Subject: Gen 5 Customer Demo Unit (CDU) and Pre-Series Unit Retrofits

Models Affected: Specific 2021 Freightliner New Cascadia model vehicles, powered with DETROIT™ Gen 5 DD15 Engines manufactured February 3, 2020, through December 14, 2020

Daimler Trucks North America LLC, on behalf of its DETROIT™ Powertrain Division, is initiating Field Service Campaign D21M6 to modify the vehicles mentioned above.

August 2021
D21M6 REV1

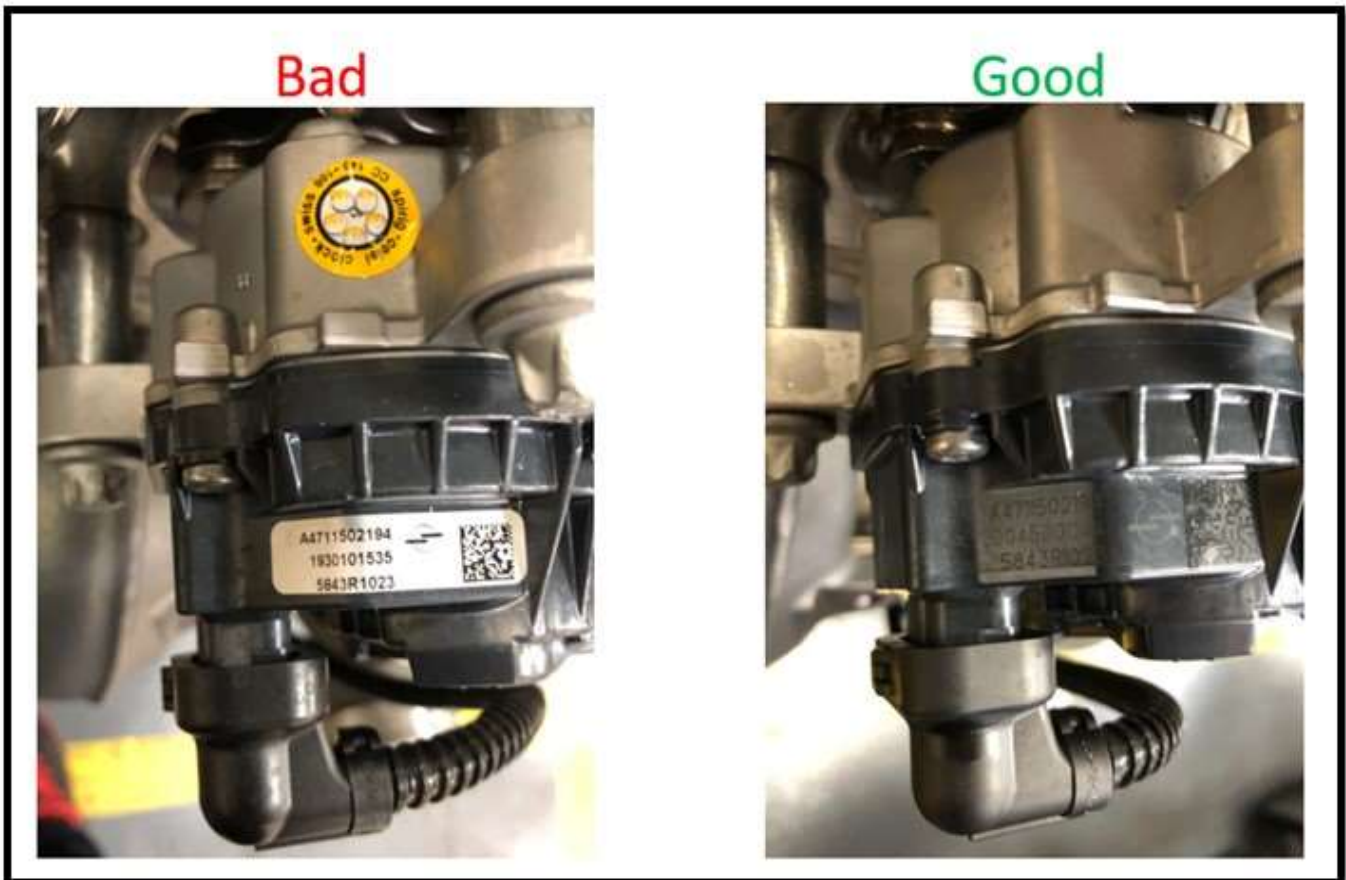
EGR Actuator Inspection

Inspect as follows:

1. Please refer to the below image.

2. If EGR actuator looks like the one in the image on the left, it will need to be replaced.

EGR hot pipe inspection

Inspect as follows:

1. Please refer to the image below.

2. The red arrow is pointing to the date found on the EGR hot pipe. The date format is DD/MM/YY.
3. If the date is 31/07/20 or earlier, the EGR hot pipe needs to be replaced. Otherwise, it can be reused.
